CERTIFICATE OF APPROPRIATENESS PLACARD

15 E MARTIN STREET

019-14-MW

COA Minor Work – Changes for 15 E Martin St

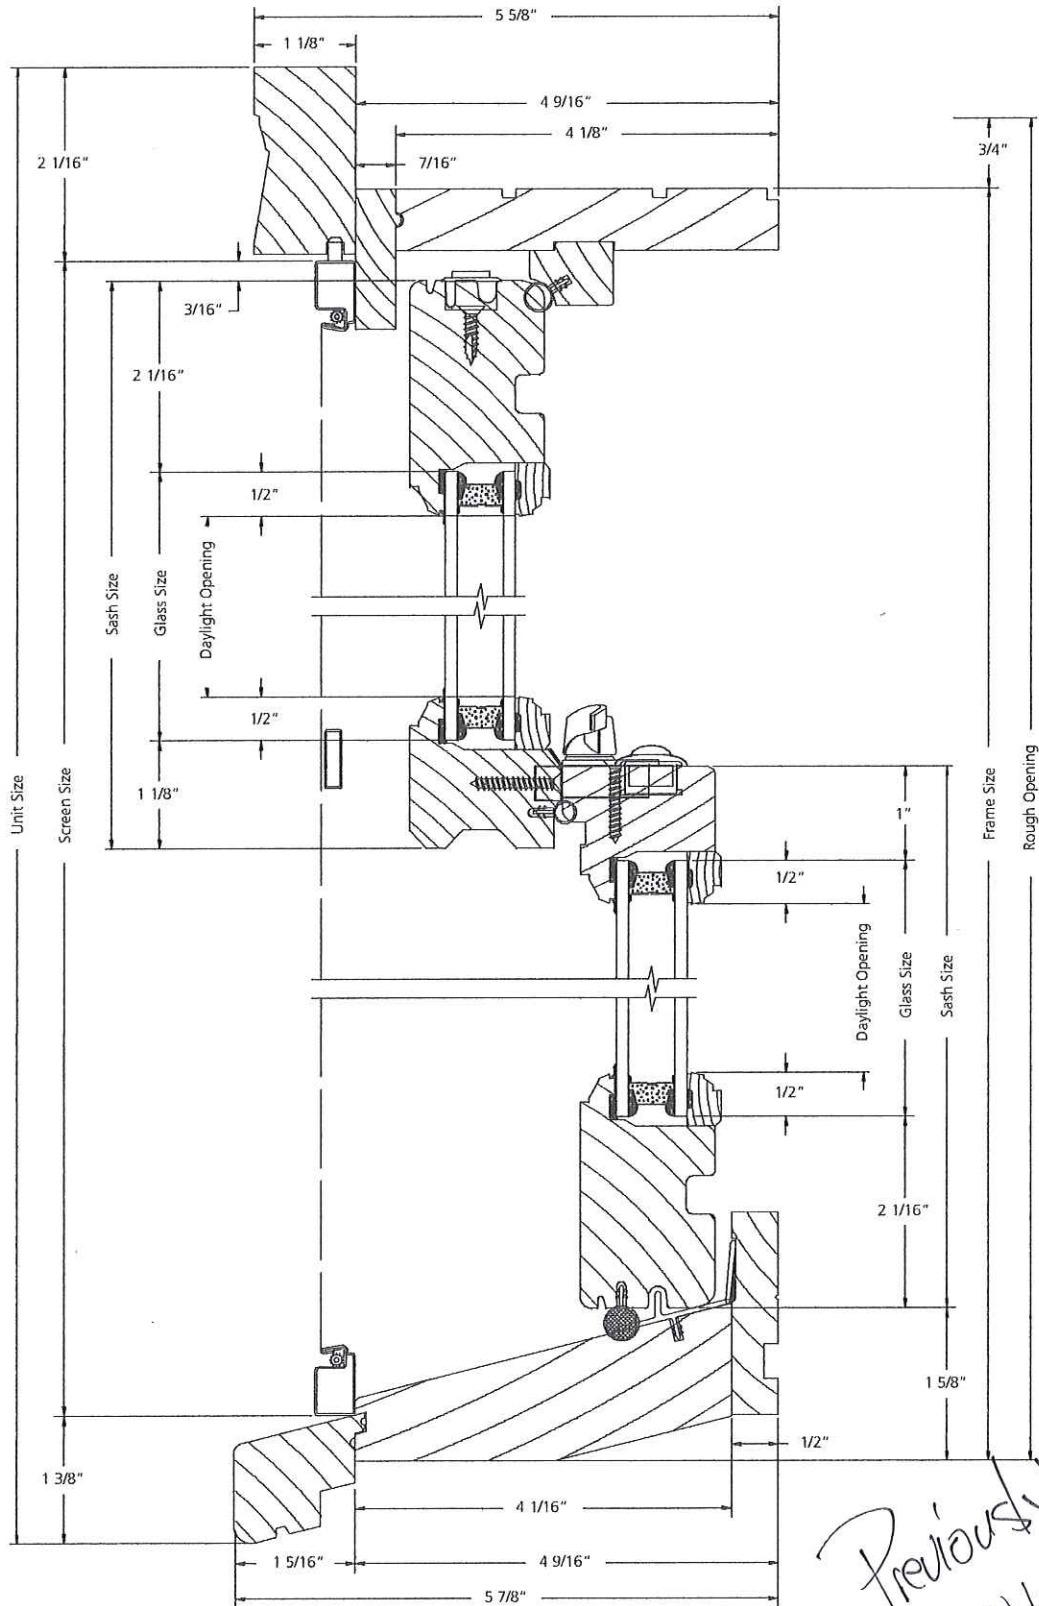
✓ Doors – Rear entry door to the building is the “front door” to the Southern’s residence. They have selected a custom Matte finish Stainless steel door with frosted glass. An image of a wood version of this door is attached along with the shop drawing from the manufacturer. The door and transom will fit the existing opening

Previously Approved T67

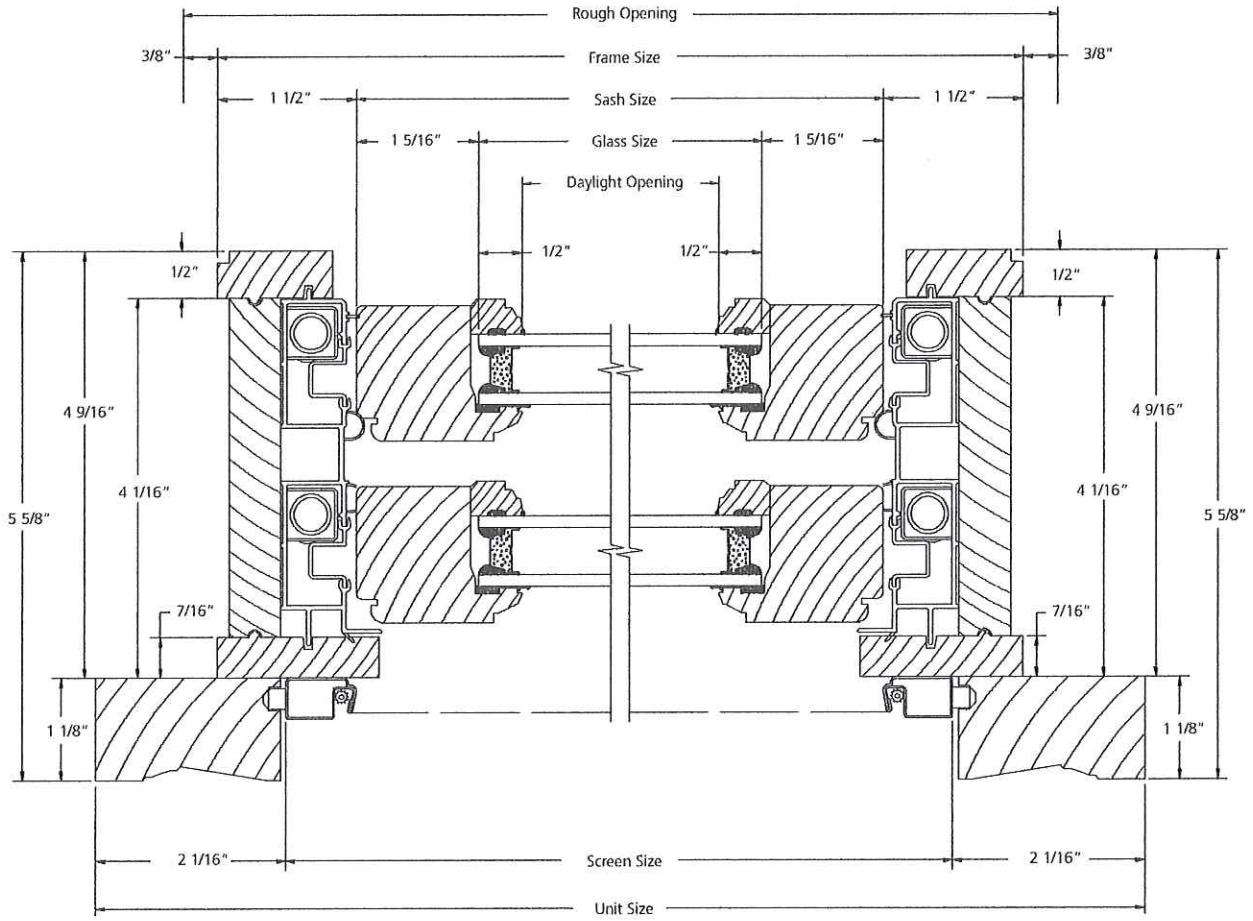
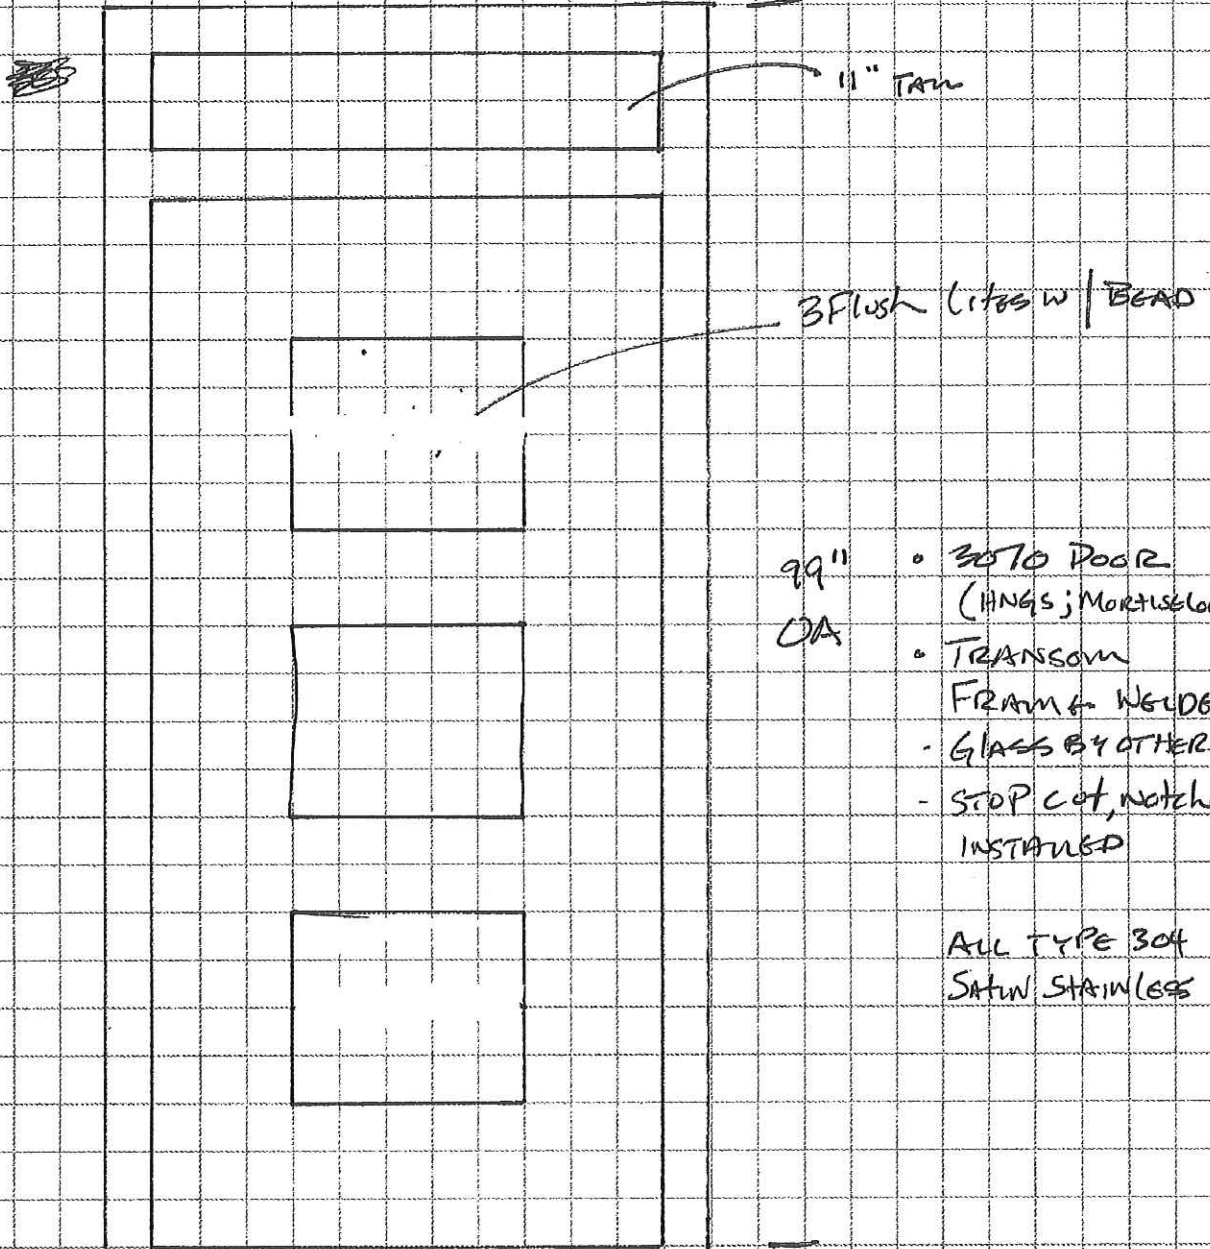
Windows- All windows will now be wood, one over one by Jeldwen Sitrine in lieu of Lincoln Wood Windows. 3rd floor has cottage style windows and 2nd level has double

Awning submittal. Inspiration image.

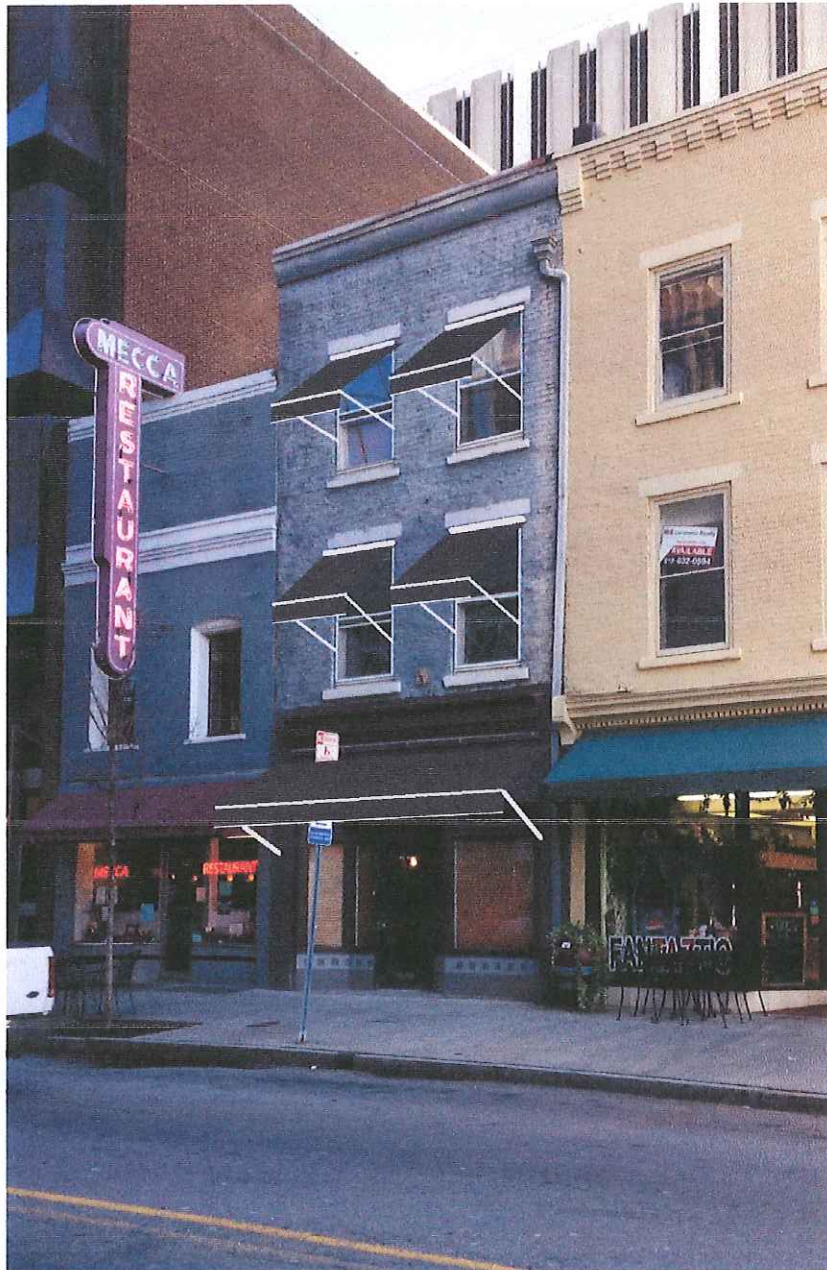
Awnings – Awnings on the 2nd and 3rd floor windows will be added to match the 1st floor. Awnings are by DAC Awnings. Fabric will be black and the supports will be a brushed metal. Inspiration image and a photoshop of Martin St are included

*design proposed is
different than approved
in 126.13.MW*

- clarification on awning mounts;
- will the window awning be mounted on the wood frame?;
- for the rear lower awning the bolts need to go through mortar joints not bricks;
- the photoshopped image shows the awning crossing a downspout – how will that be handled?;
- awning dimensions; A drawing from the company is ideal
- The application states that the new awnings are to match the 1st floor awning, but the design of the awnings is different than the original approval. The awning originally approved did not have a valance. The valance is approvable, but I need to be certain that you understand that it is different than the original approval.
- Confirmation that the masonry headers and sills are not being painted.
- And as I said on the phone, payment of the \$28 application fee (reference transaction number 388326)

Sills and headers won't be painted, they look awesome! I'll get awning guy to provide more details because that photoshop picture was his doing. Yes the first floor awnings are different from the original COA, but I meant that they will all match this new redesign. The gutter will be slightly rerouted around the awning. It kicks over to the drain a little lower down so I thought we'd just kick it over sooner.

The window awnings will have clips that mount to the window frame and attach to the building at mortar joints.

Materials and labor to fabricate and install ten (10) fabric awnings for the project at 15 E. Martin Street in Raleigh. All of the awnings will have a 2'6" drop & 3' projection with the eight upper floor window awnings at 3' wide & first floor awnings 14'6" & 11'6" wide.
